Gachsaran Polymer Industries Company PIDMCO	Gachsaran Polymer Industries Company HDPE Plant Evaporator (Chiller) Drawing

PO No.: GPIC-PT-MA-PO-000-3029	Document Number: VD-GPIC-MA-3029-3029-0089	Rev. 01	Page 1 of 10

Evaporator (Chiller) Drawing

PO No.: GPIC-PT-MA-PO-000-3029
 DRAWING TITLE: EVAPORATOR (CHILLER) DRAWING (E-6101) (GENERAL ARRANGEMENT)
 DRAWING NO.: VD-GPIC-MA-3029-3029-0089
 REV. SHEET NO. SIZE: 01 3 of 10 A3

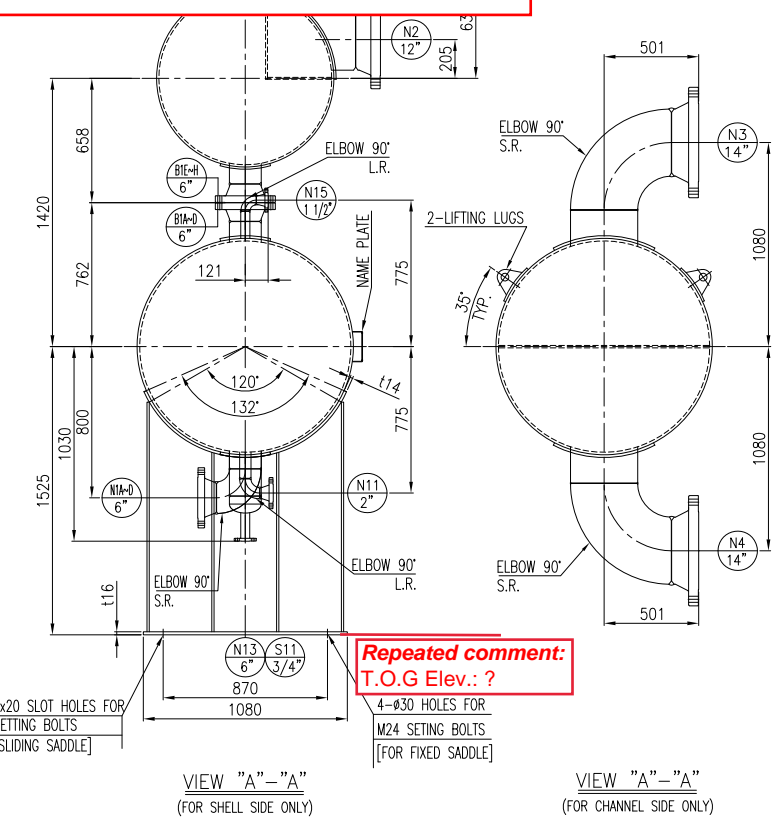
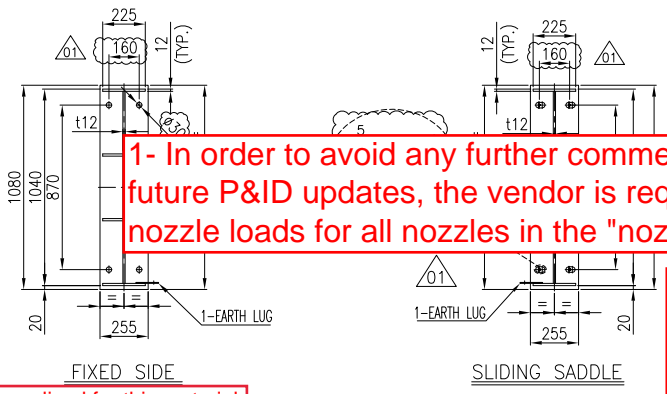
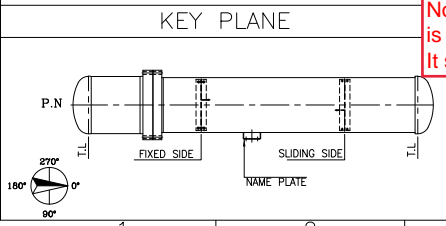
PI COMMENT:
 Repeated comment
 -This drawing is related to the inside of the package and the design of the equipment inside the package is outside client (EIED) scope of work and shall be handled by the vendor; therefore, the client (EIED) does not have any comment on detail drawing of equipments inside refrigerator package.
 - The client (EIED) receive refrigerator package on skid; therefore, the size and rating and location of the lines at the Ti-in with the client will strictly be reviewed in the document of general arrangement drawing for refrigerator package.
 -The 3D model must be prepared by vendor.

Recommendation:
 It is better to revise the nozzle location and number/location of the baffle according to the comments on the previous revision.

Repeated comment:
 T.O.G Elev.: ?

1- In order to avoid any further comments/change in accordance with future P&ID updates, the vendor is requested to specify the allowable nozzle loads for all nozzles in the "nozzle table".

EIED Comments:
 according to Insulation specification (GPIC-DD-PI-SPC-000-0009-04) insulation thickness shall be 40mm.

Repeated Comment:
 According to the conclusion of reply sheet, all discrepancy between Mechanical Calc. and GAD (Name, Size, thk,...) shall be removed.

Normalized for this material is applicable?! It seems that is not true.

Normalized for this material is applicable?! It seems that is not true.

Repeated Comment:
 MDMT Required/Computed

Repeated Comment:
 PFHT only for heads

Repeated Comment:
 ap, z/h shall be added.

Repeated Comment:
 Pulling load shall be added (1.5*Bundle weight)
